Dampened response

The Glitch:

An installer is asked to pipe two independent zones of high mass floor heating to a conventional gas-fired boiler. The layout he chooses is shown in Figure 1. Two 1-inch pipe size thermostatic mixing valves are used to provide two different supply temperature settings. Each manifold station is expected to operate at 10 gallons per minute of flow.

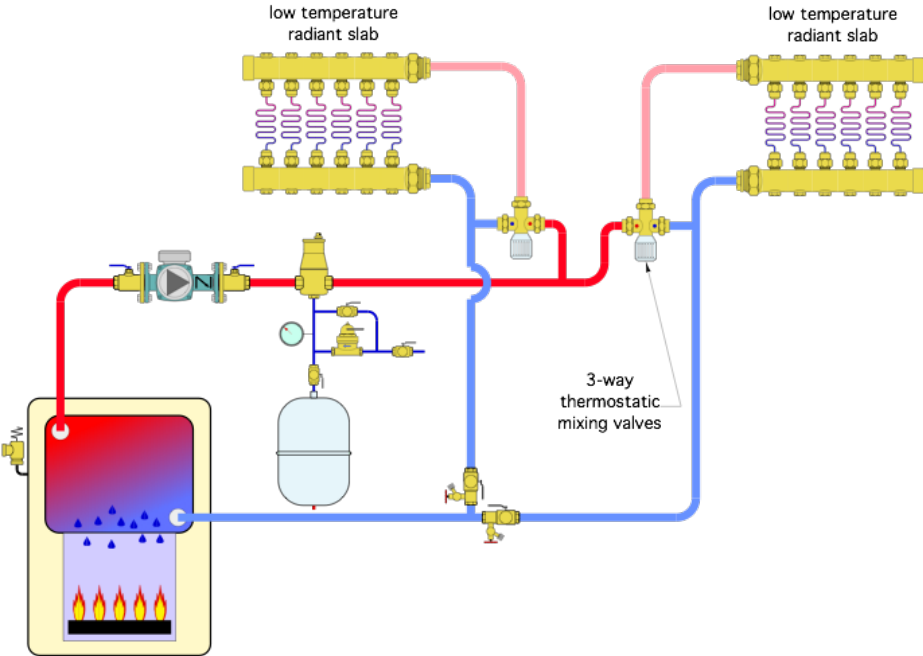
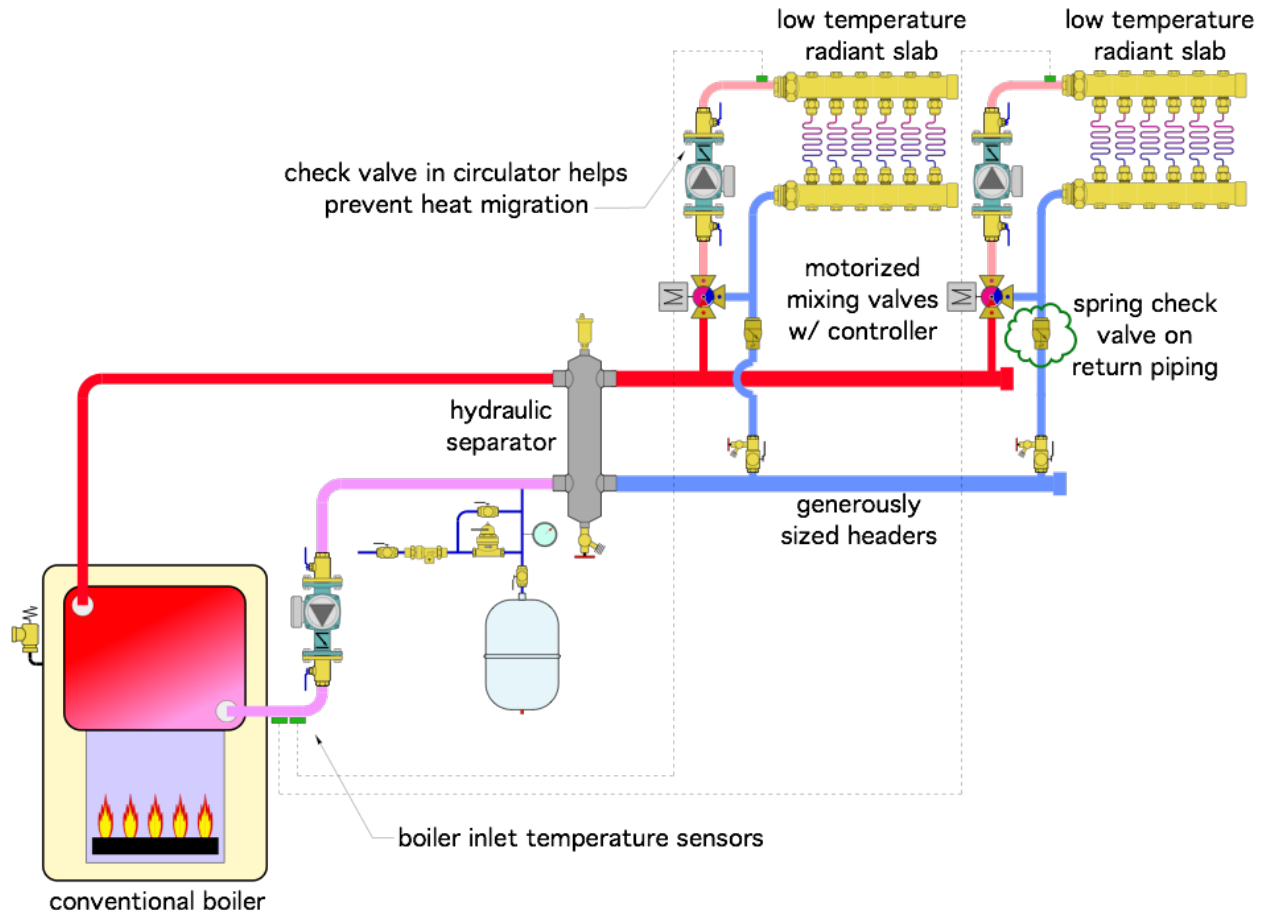
Several errors are present in the original drawing. They are listed below. Figure 2 shows one way to correct all of them.

1. There will be very little (and very inadequate) flow through the radiant panel circuits because there are no circulators between the mixing valves and their respective manifold stations. The revised schematic shows a separate circulator for each zone. Those circulators are placed between the mixing valve and manifold station.

2. There is no detail to protect the conventional boiler against sustained flue gas condensation. See point 6 below for how this has been corrected.

3. The circulator shown is placed upstream of the point where the expansion tank connects to the system. Circulators should always pump away from the point where the expansion tank connects to the system, and there should be low flow resistance between this point and the inlet of the circulator. This is accomplished by a generously sized header in the revised schematic.

4. There is no backflow preventer in the make-up water system. This is a violation of most mechanical/plumbing codes. The revised schematic has a backflow preventer in the make-up water system.

5. The purging valves are installed backward. The revised schematic corrects this detail.

6. Just because the thermostatic mixing valves have 1-inch piping connections doesn't mean they are adequate for several gallons per minute of water flow. Most small thermostatic mixing valves — up to 1-inch pipe size — are intended for use as tempering devices in domestic hot water systems. They typically have low Cv ratings and thus create very high flow resistance when used in hydronic heating systems where several gallons per minute of flow are expected. This problem and the lack of flue gas condensation protection described in No. 2 above, has been corrected by using motorized mixing valves operated by electronic controllers that sense and react to boiler inlet temperature to prevent sustained flue gas condensation.

7. There are no check valves to prevent flow reversal through one of the zones when it is off and the other zone is on. Check valves have been added to the revised schematic.
